Access Compliance Report

Public Rights-of-Way

Intersection ID: 27766	Main Street: BLAKENEY_HEATH_RD	Cross Street: BRYANT_FARMS_RD	Location: S
ADA ID: 2DB6F96DB712	Ramp Type: Directional	Initial Pass/Fail: Fail	Overall Compliance: No
		Severity Score: 1.25

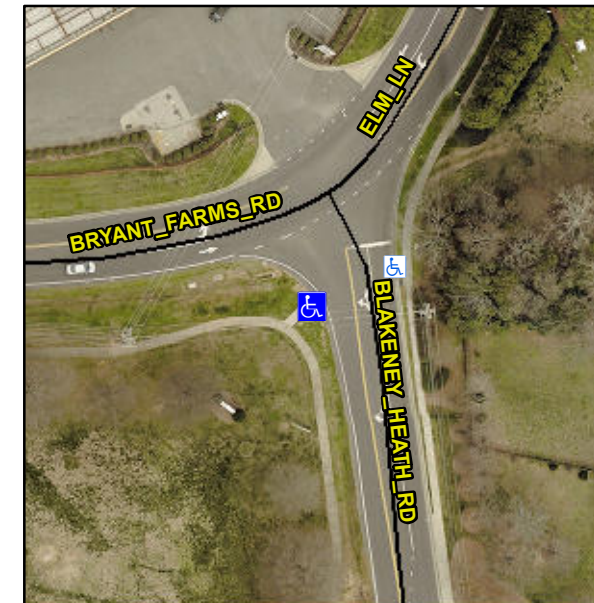
R304.5.3

Compliance	Description	Data	Compliance	Description	Data
N/A	Ramp Length (in)	47.0	N/A	Grade Break?	N/A
Yes	Ramp Width (in)	57.0	N/A	Grade Break Slope (%)	0.0
Yes	Ramp Slope (%)	5.1	N/A	Grade Break XSlope (%)	0.0
No	Ramp XSlope (%)	4.5			
N/A	Flare Type LT	N/A	N/A	Flare Type RT	N/A
N/A	Flare Slope LT (%)	N/A	N/A	Flare Slope RT (%)	0.0
N/A	Flare Traversable LT?	N/A	N/A	Flare Traversable RT?	N/A
N/A	Landing Length (in)	0.0	N/A	DWS Provided?	N/A
N/A	Landing Width (in)	0.0	N/A	DWS Contrast?	N/A
N/A	Landing Slope (%)	0.0	N/A	DWS Length (in)	N/A
N/A	Landing X Slope (%)	0.0	N/A	DWS Full Width?	N/A
N/A	Landing Curb? (Y/N)	N/A	N/A	DWS Offset LT (in)	N/A
N/A	Shared Landing?	N/A	N/A	DWS Offset RT (in)	N/A
N/A	Gutter Ponding?	0.0	N/A	Gutter Slope (%)	N/A
N/A	Gutter Lip Ht (in)	0.0	N/A	Gutter X Slope (%)	N/A
N/A	Painted X Walk1?	No		Road Slope (%)	1.9
	X Walk 1 Direction	To NE		Road X Slope (%)	6.4
	X Walk 1 Width (in)	N/A		Clear Space?	N/A

Remove & Replace Entire Ramp.
